**Addendum No. 2
February 16, 2023**

Project: Harrisburg Elementary School #8
Harrisburg, South Dakota
Architecture Incorporated Project #3000

Architect: Architecture Incorporated

4.34

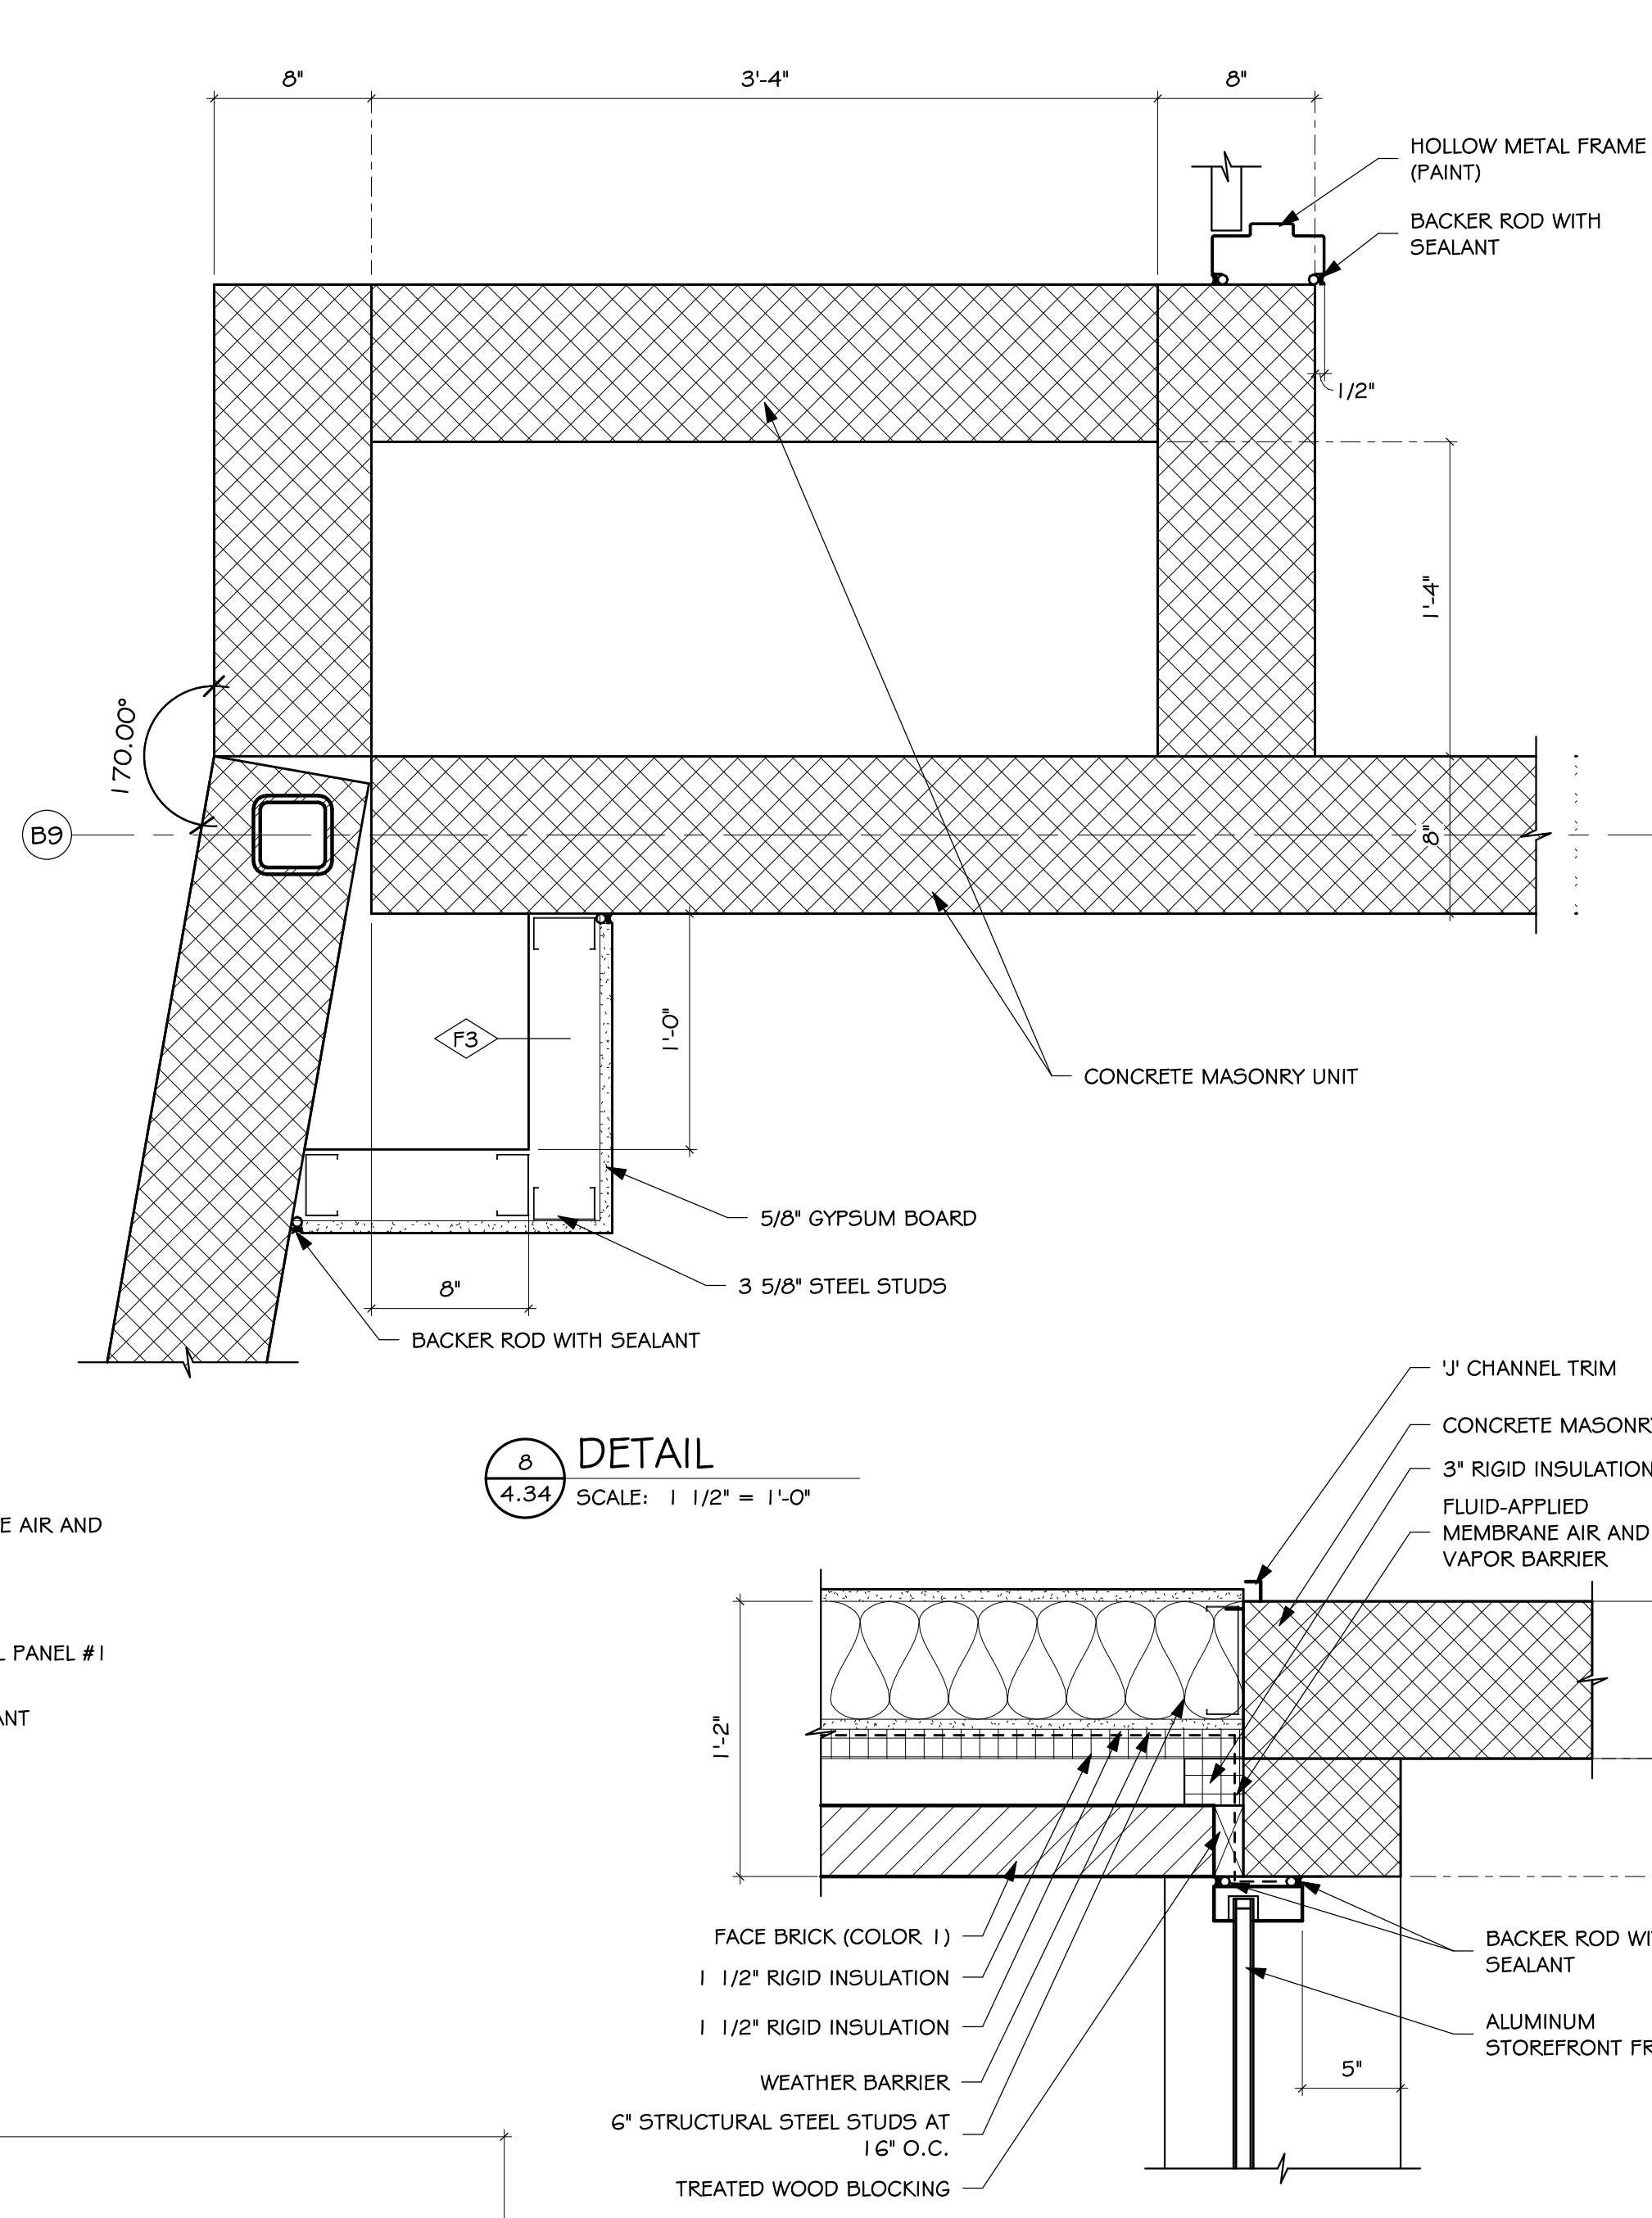
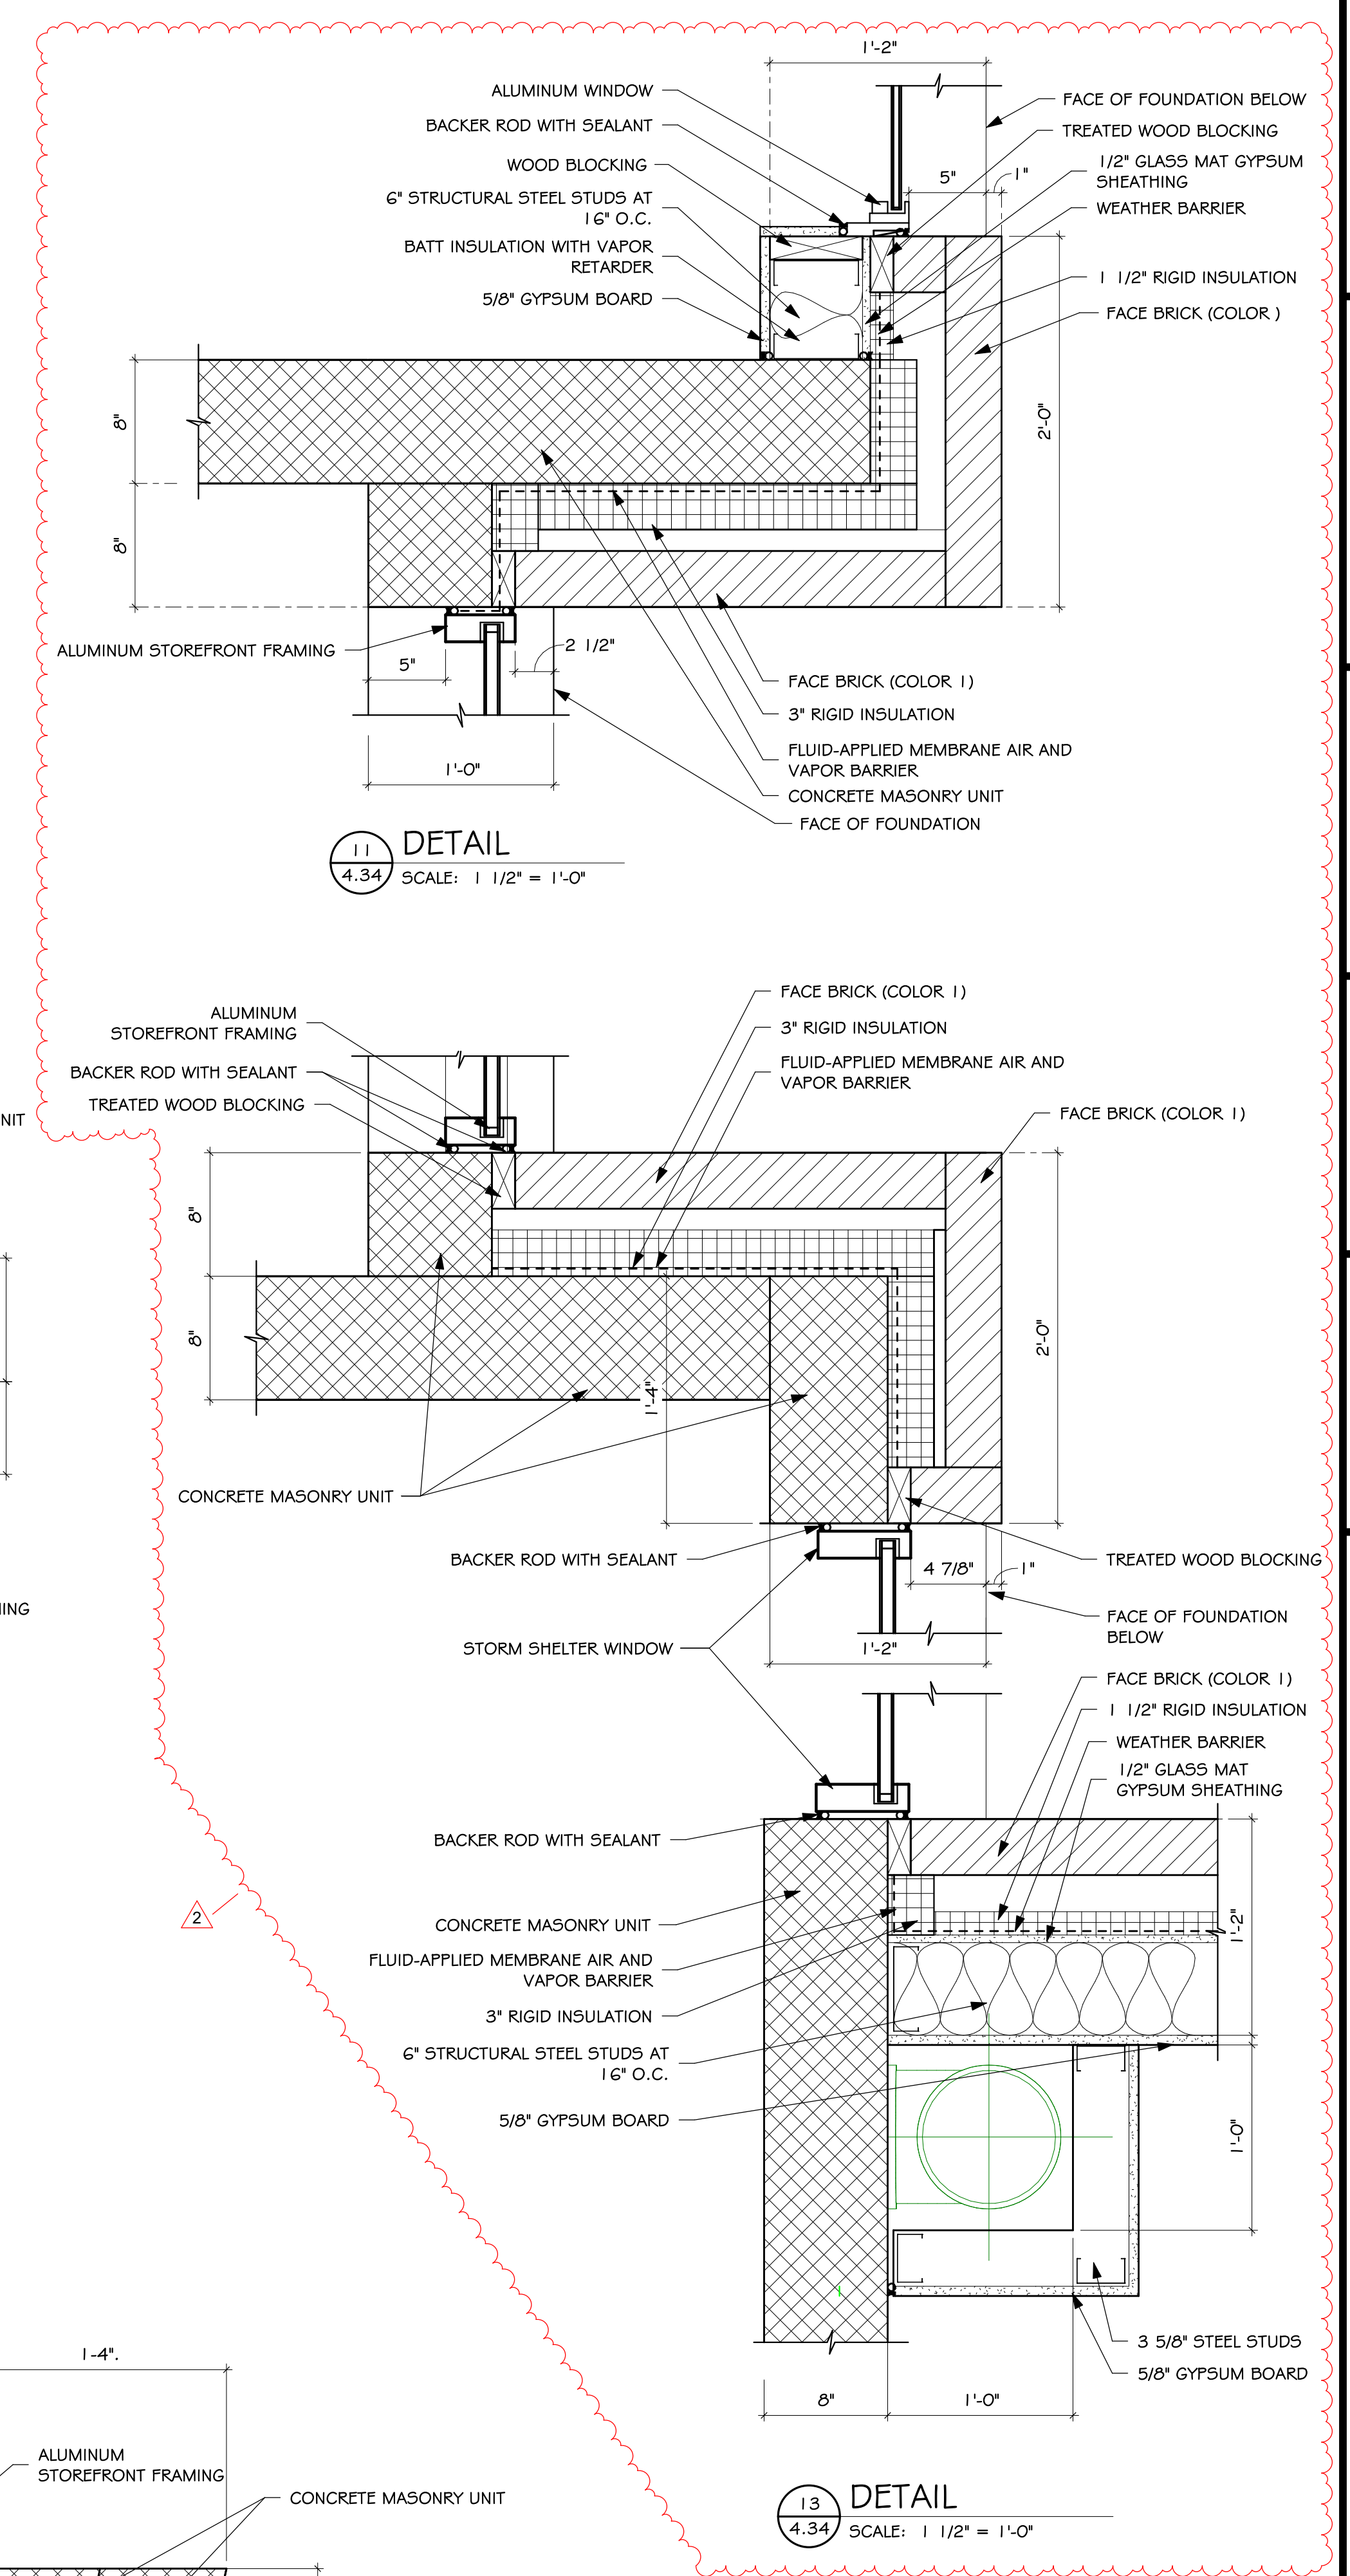
- a) Revise aluminum window jamb detail 11/4.34 as indicated per *revised* drawing Sheet 4.34, dated 2-16-23; see revised drawing Sheet 4.34 attached to the end of this addendum for additional information.
- b) Revise (Type F) storm shelter window jamb detail 13/4.34 as indicated per *revised* drawing Sheet 4.34, dated 2-16-23; see revised drawing Sheet 4.34 attached to the end of this addendum for additional information.

15 HEAD DETAIL - STORM SHELTER WINDOW
5.14 SCALE: 1/2" = 1'-0"

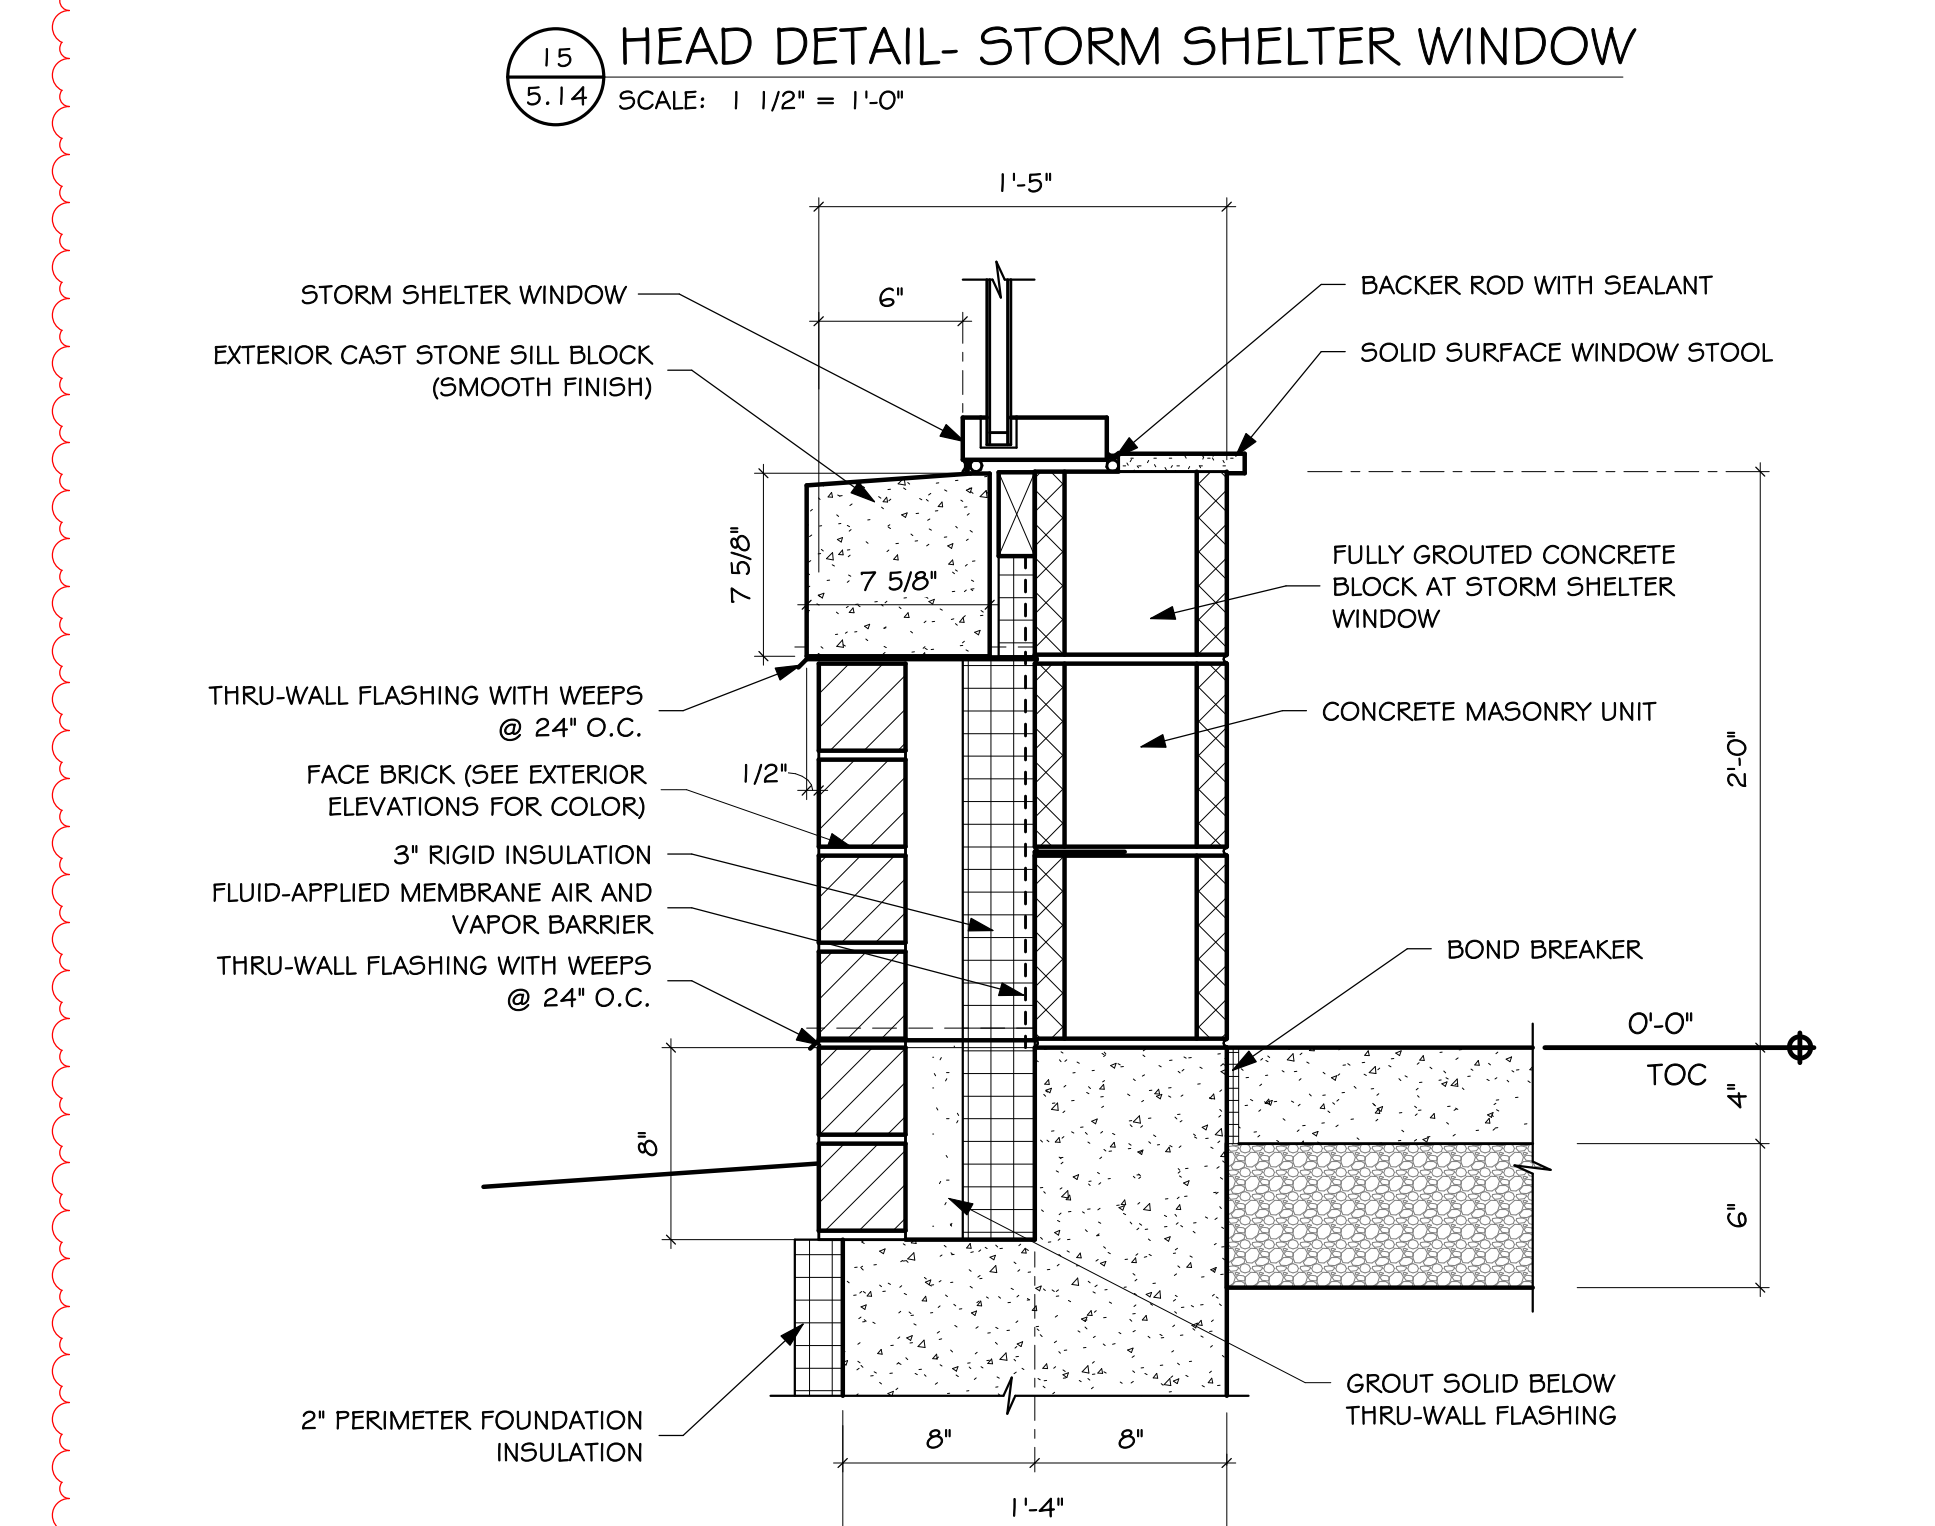
- a) Exterior Storm Shelter Window Details: Reference newly added HEAD DETAIL - 15/5.14 and SILL DETAIL - 16/5.14 on *revised* drawing Sheet 5.14, dated 2-16-23, attached to the end of this addendum for correct Type F window head and sill details.
